Request for Change Order

La Vernia ISD 2023 Bond Projects (231091)

No. RCO0099R1

Description	PR#78 - Band Hall Storage & Blocking	Date	2026-06-29
Status:	Pending Review - Forecast	Days Impact:

FLOOR PLAN -
LEVEL 01 - SEG. J
A02.01J

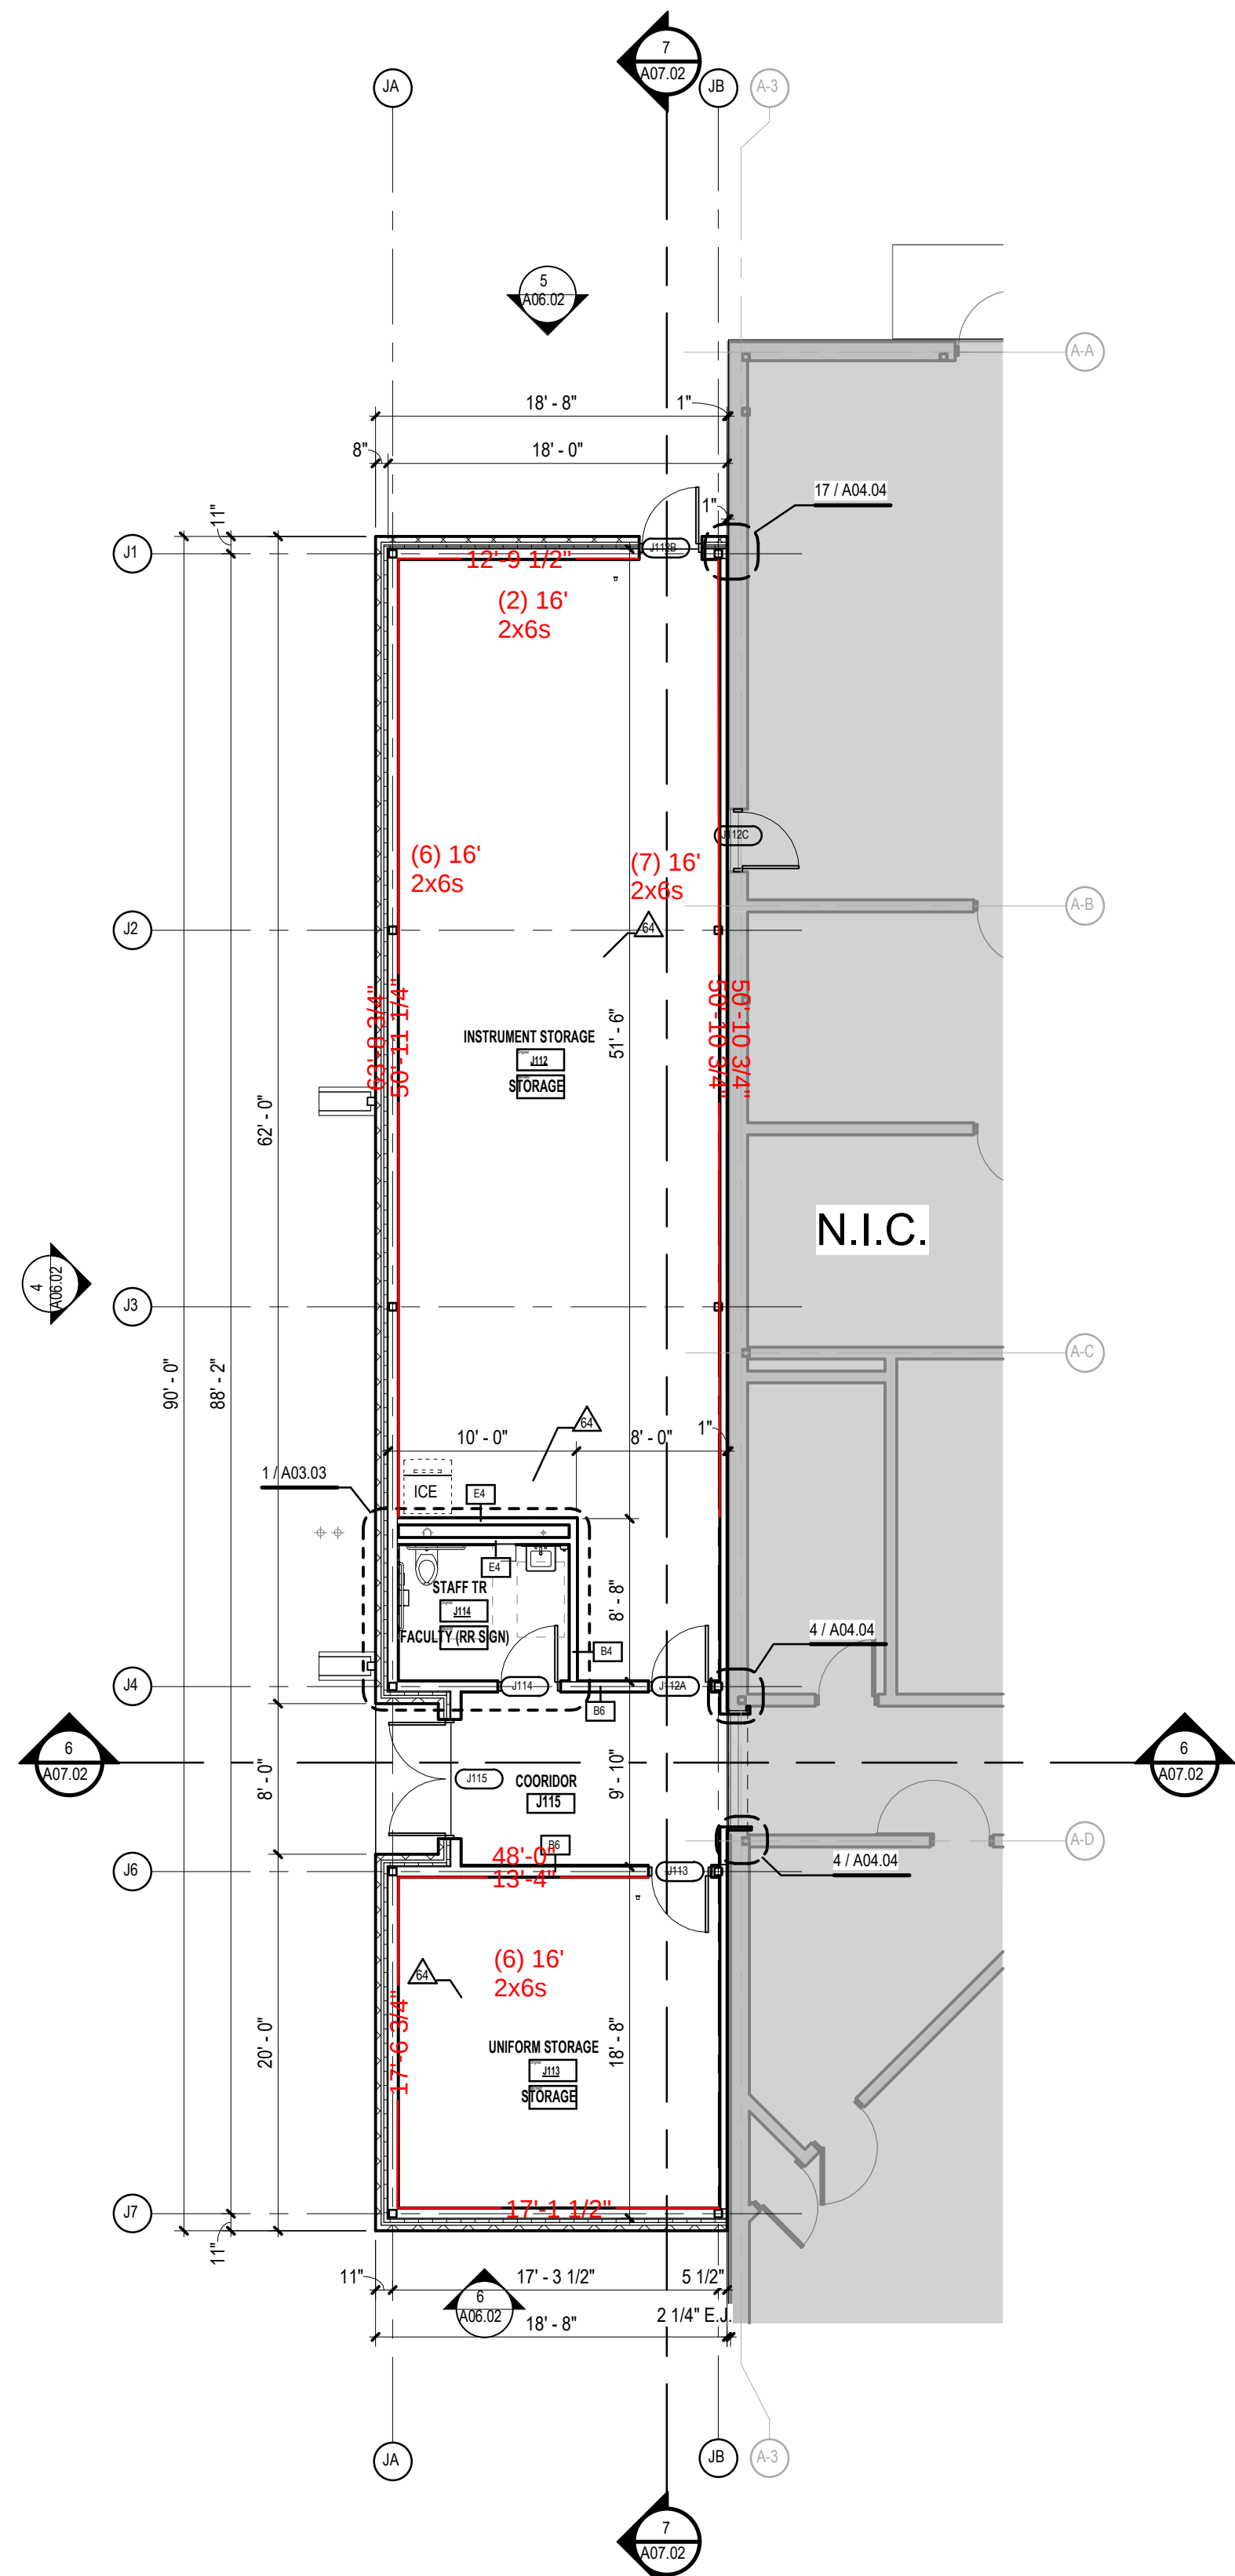
BC SP: Provide and install fire treated 2x6 in-wall blocking at HS and JHS Band Halls for Instrument Storage Shelving.

FLOOR PLAN -
LEVEL 01 - SEG. K
A02.01K

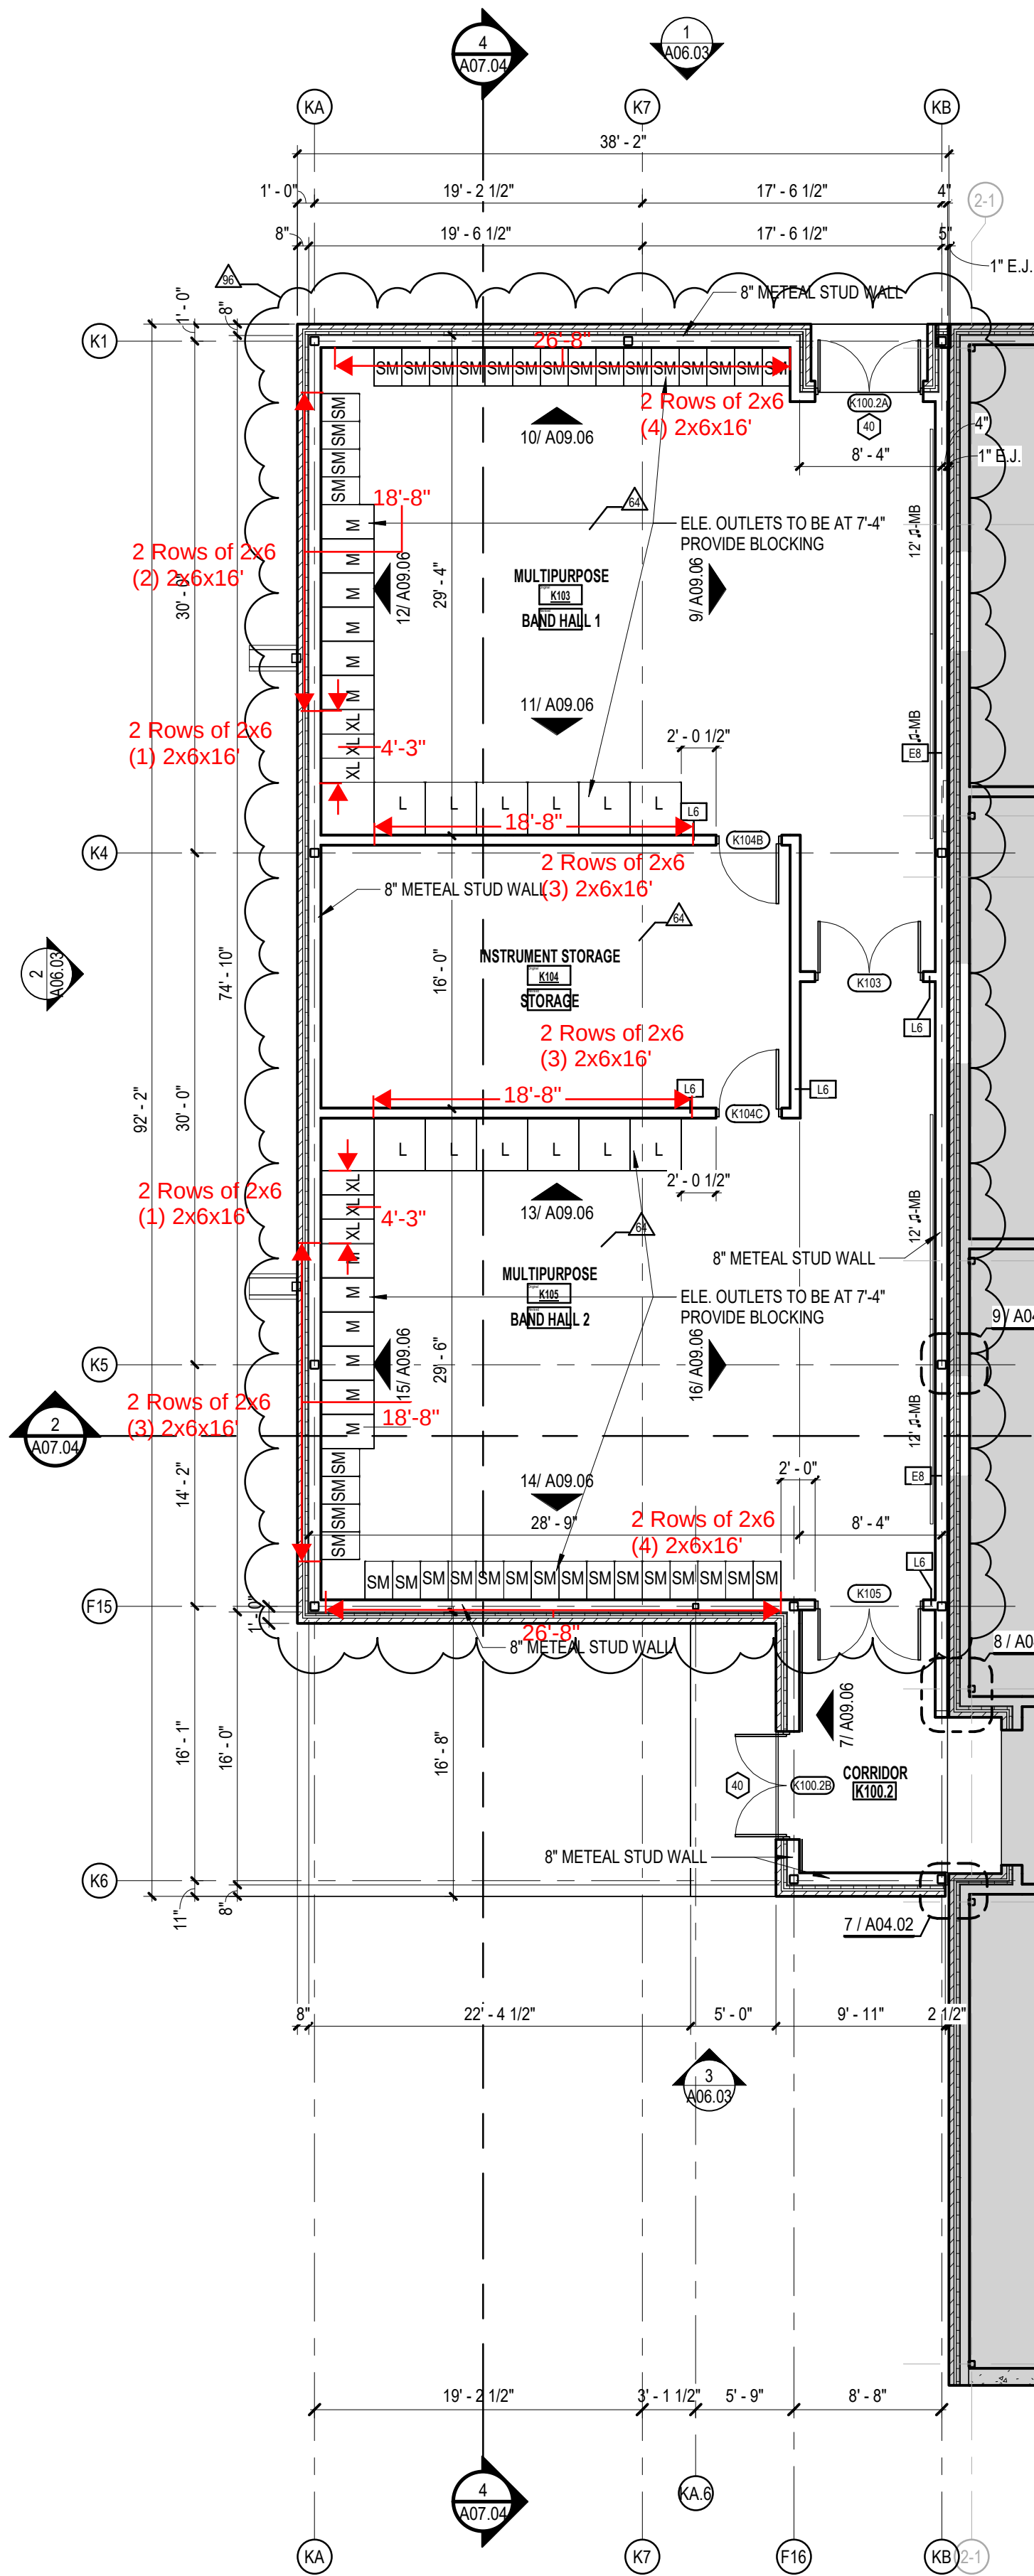
Here is the information for in-wall blocking for Gear Boss Shelving system.

Please add at all walls with red highlight below.

FLOOR PLAN -
LEVEL 01 - SEG. K

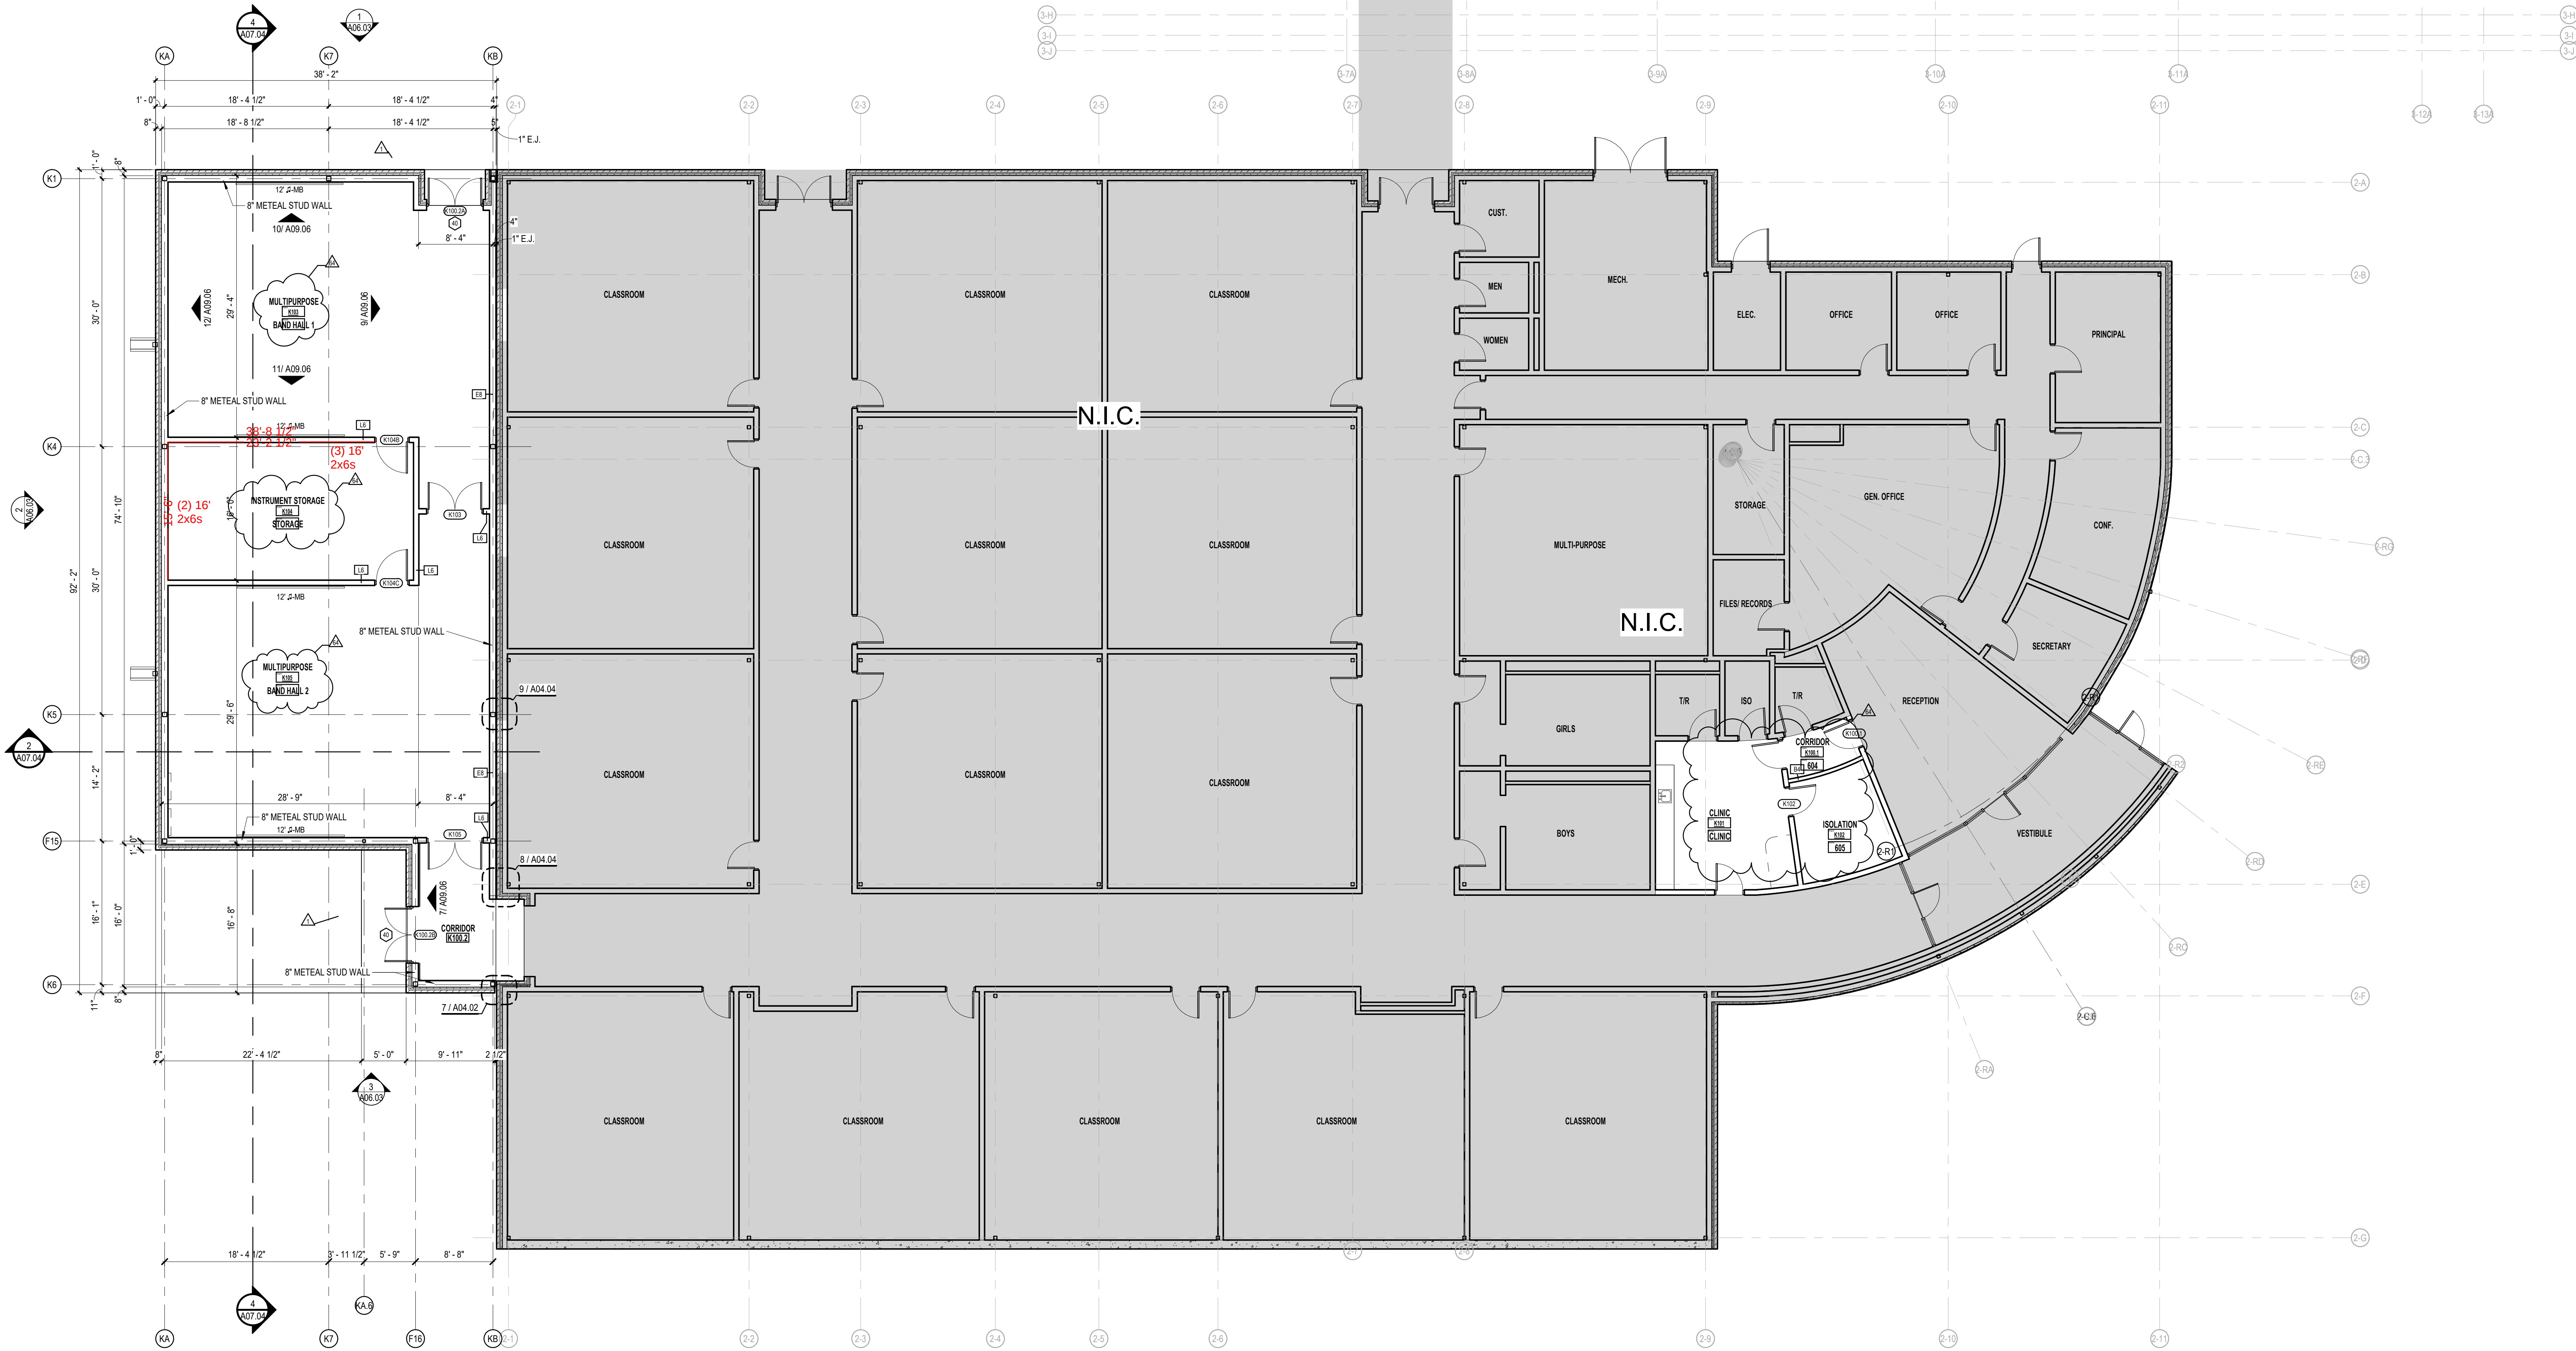
Provide a cost estimate for the revised layout of the band lockers, GC to provide blocking for band lockers and to relocate the outlets to be at 7' – 4".
